STAFF REPORT
PLANNING AND ZONING COMMISSION
For the April 30, 2015 meeting

SUBJECT: Site Plan Review for Windsor Crossing Senior Living Facility

The City's Engineer reviewed the initial site plan with the following comments below. Staff is waiting for a full review of the site plan and specifically stormwater comments from the engineer, but should have a final comment from the engineer at the time of the meeting. The applicant has already worked to address most of the issues and is shown in the site plan that the Planning and Zoning Commission has been given, but staff wanted to give the Planning and Zoning Commission a copy of the initial comments in case there are questions related to them. A final building permit will not be issued until all issues are resolved.

DIMENSION/LANDSCAPE

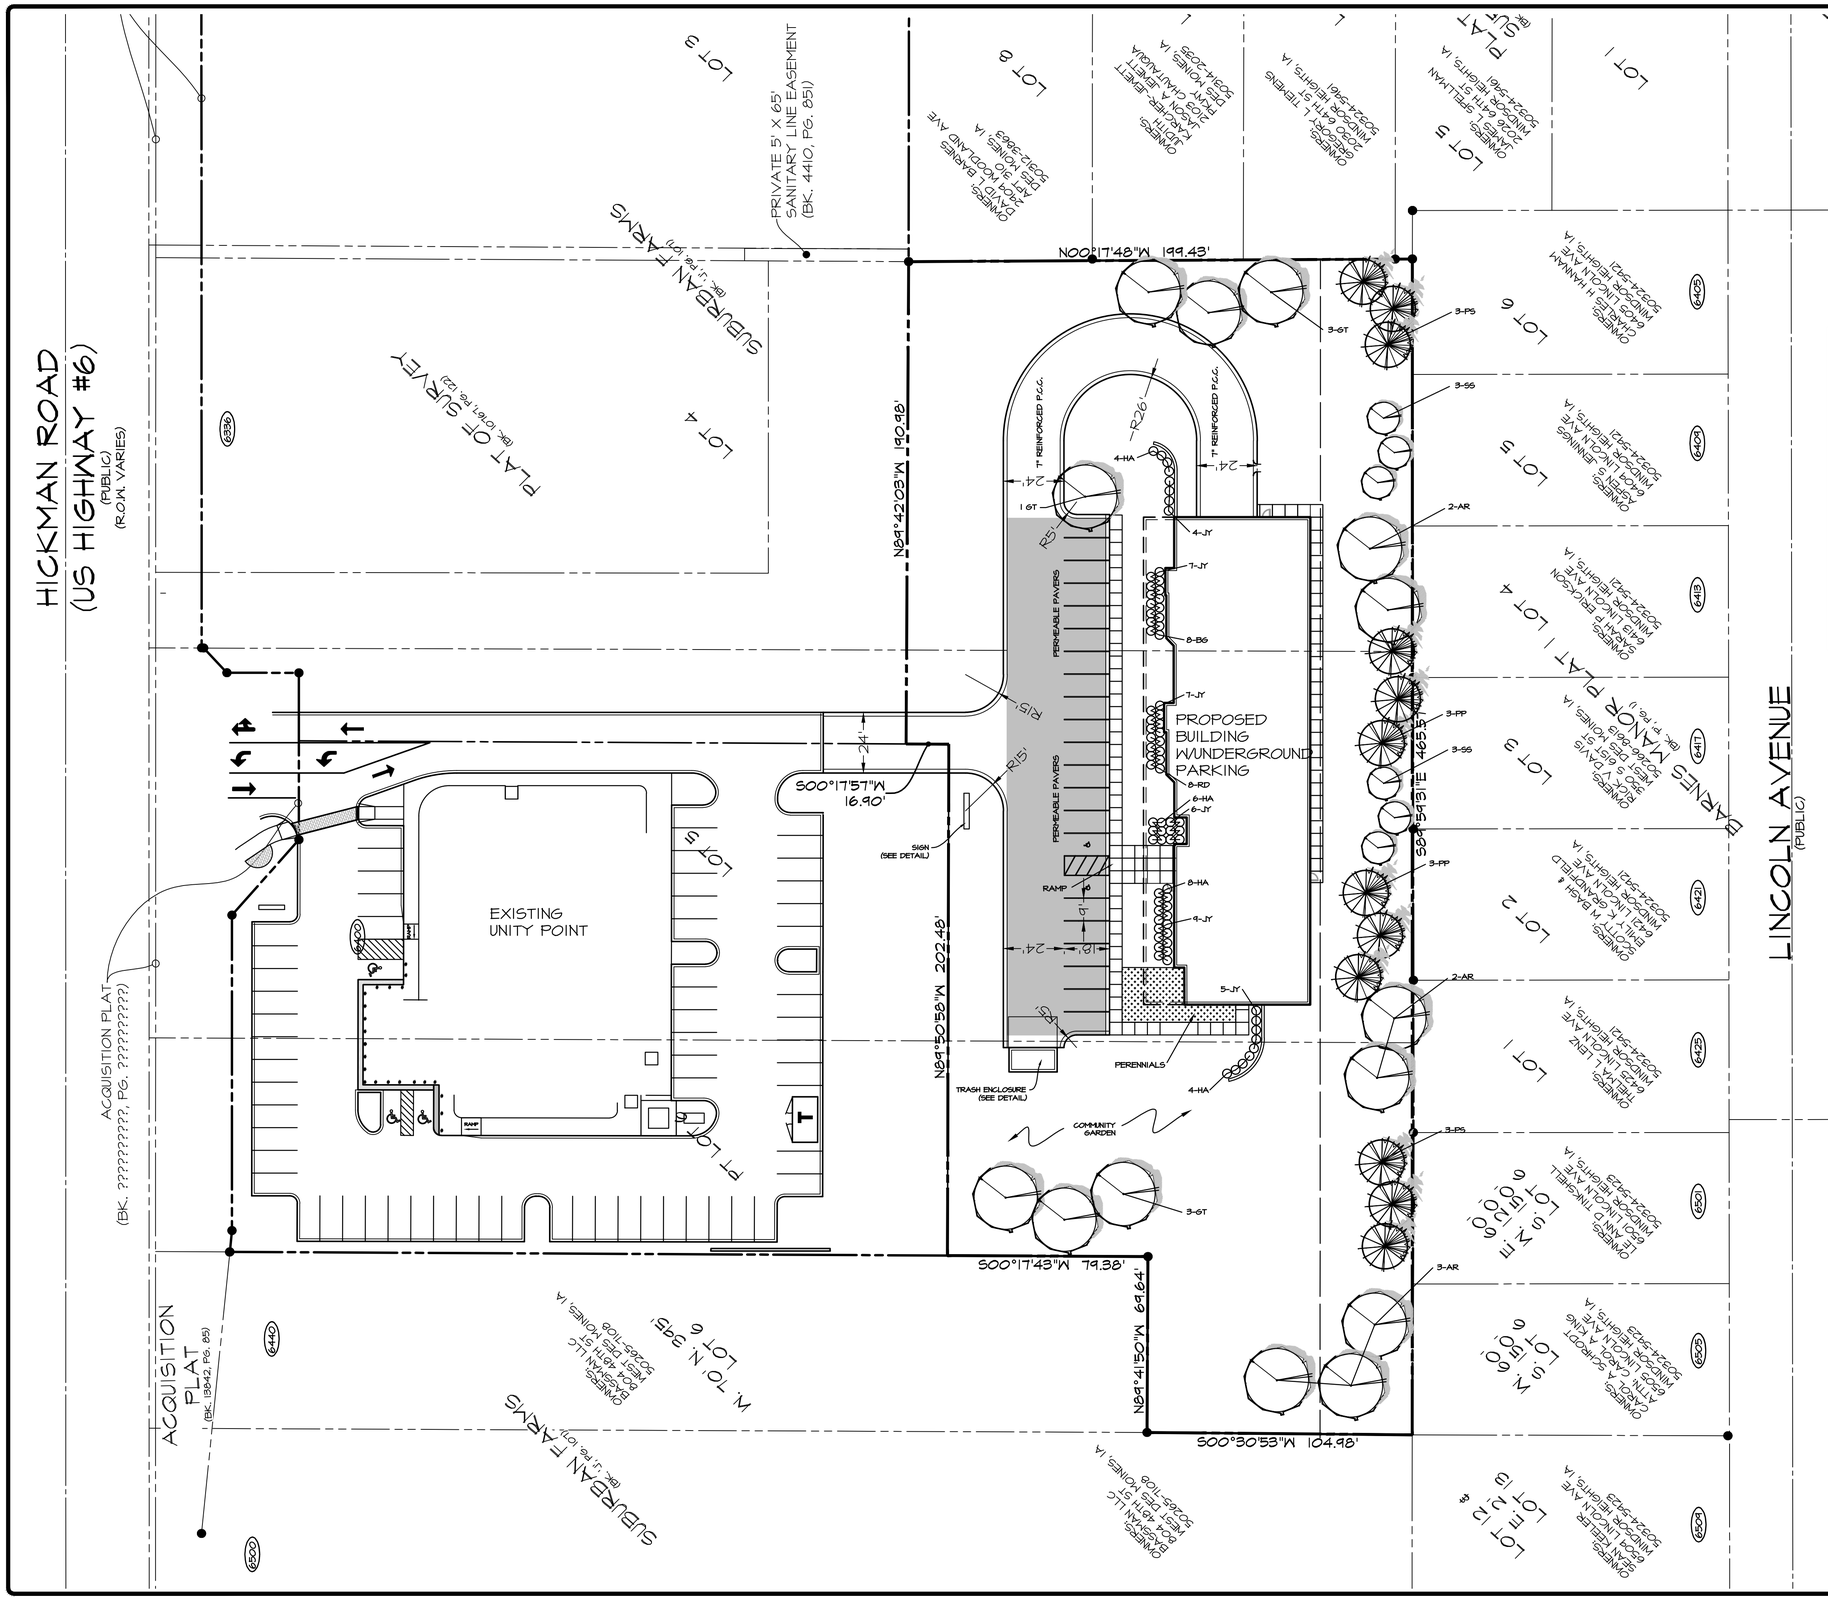
- Need a copy of the storm water calculations.
- North arrows need correcting (sheets 2 and 3) as to not confuse PnZ or Council on orientation
- Need to see construction details for permeable pavers, parking lot and walks etc.

- Looks like a water service easement will be needed near Hickman Road.
- I believe the scale is incorrect on the two site plan drawings.
- The drive ramp may need to be widened to accommodate head to head traffic on the curve.

WEST ELEVATION

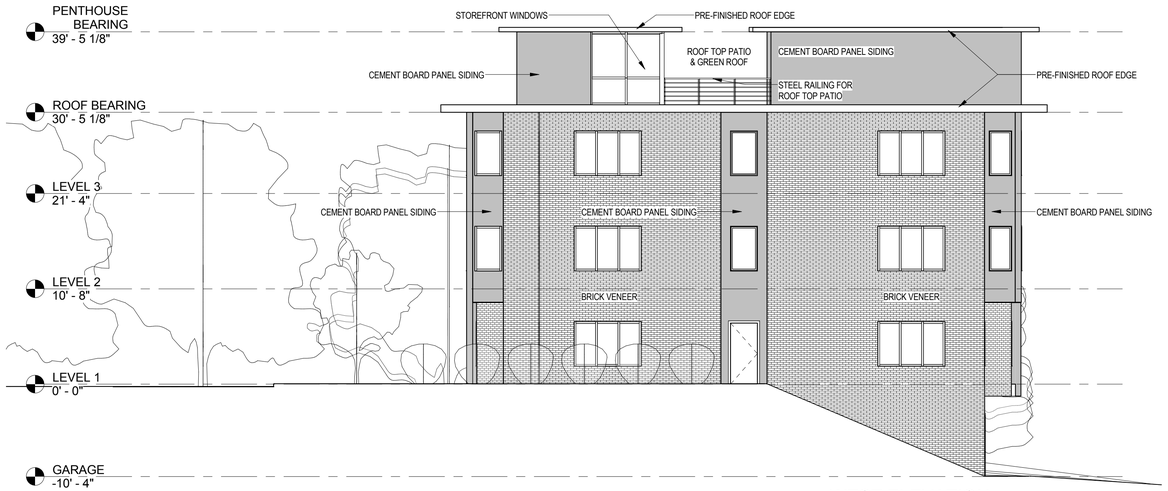
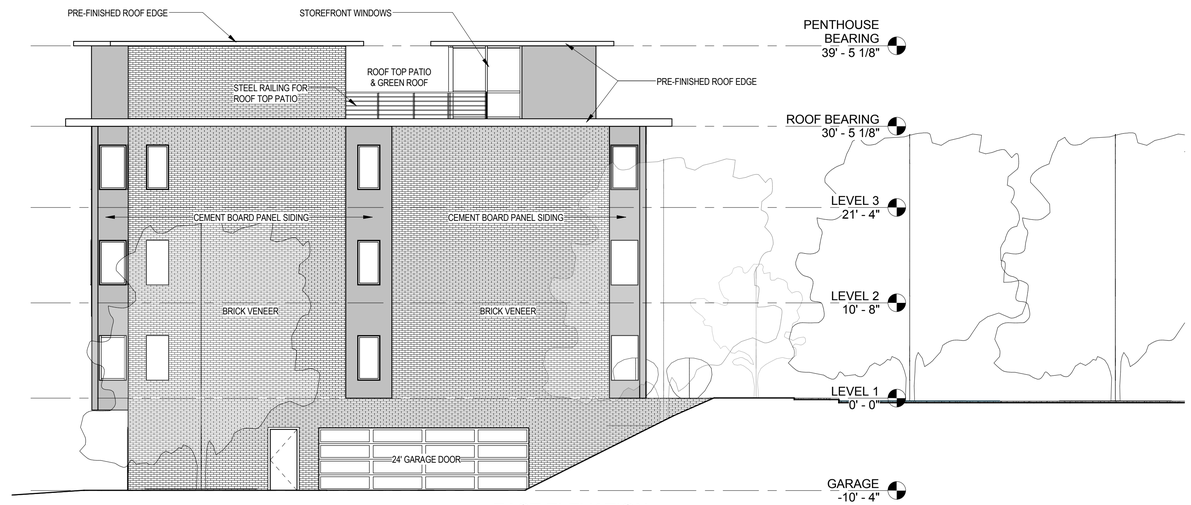
- Flows along the NW property line used to sheet flow, now are swaled along the property line.
- East and west elevations do not show retaining walls.
- Will the west retaining wall have a rail near the building adjacent to the walk?
